## Product Change Notice (PCN)

**PCN Number:** PCN-0451320R-01

**Product(s) Affected:** PDP-30

**Description of Change:** housing and materials changes as shown below.

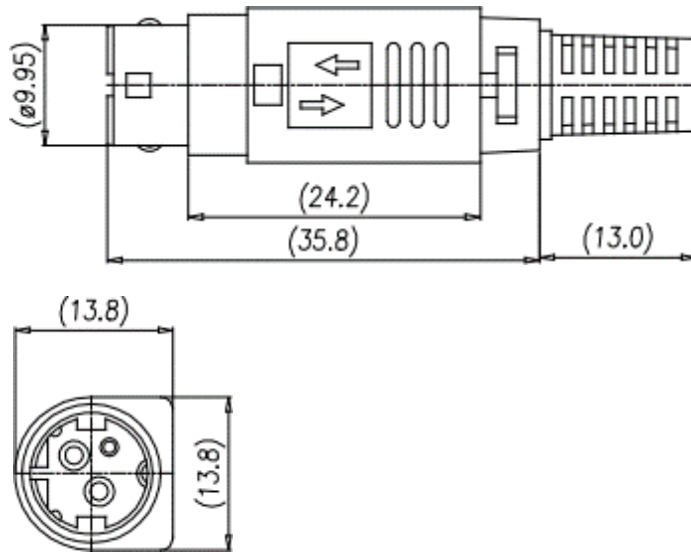
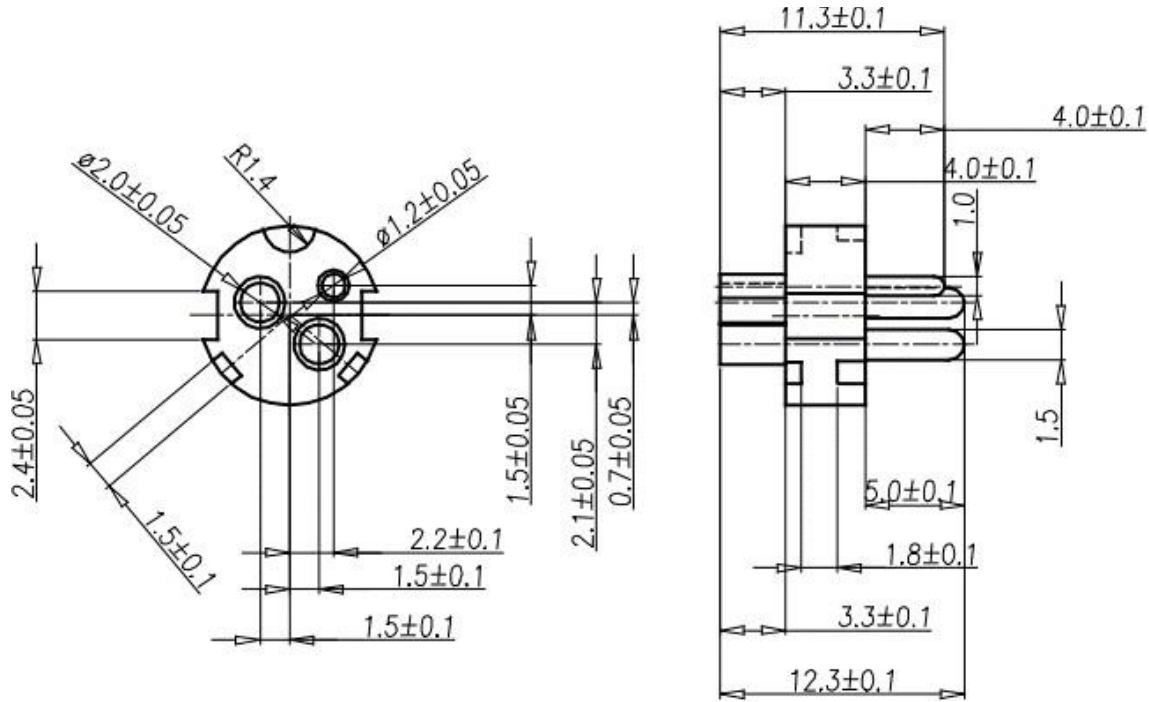
**Reason(s) for Change:** manufacturing build location change.

MATERIAL	PLATING
OUTER HOOD	ABS	
METAL SLEEVE	Brass	Nickel
CLAMP	Brass	Nickel
PIN/BODY	Brass/PBT	Silver
PLASTIC RING	POM	
METAL COVER	Brass	Nickel
SPRING	Steel	
INNER HOOD	ABS	
STRAIN RELIEF	PVC

MATERIAL	PLATING
housing	PBT (UL94V-0)	
contacts	copper alloy	silver
plastic cover	ABS	
metal shell	copper alloy	nickel
metal cap	copper alloy	nickel
cable fixer	copper alloy	tin
ring	POM	
spring	steel	nickel
plastic tube	ABS	
SR	PVC
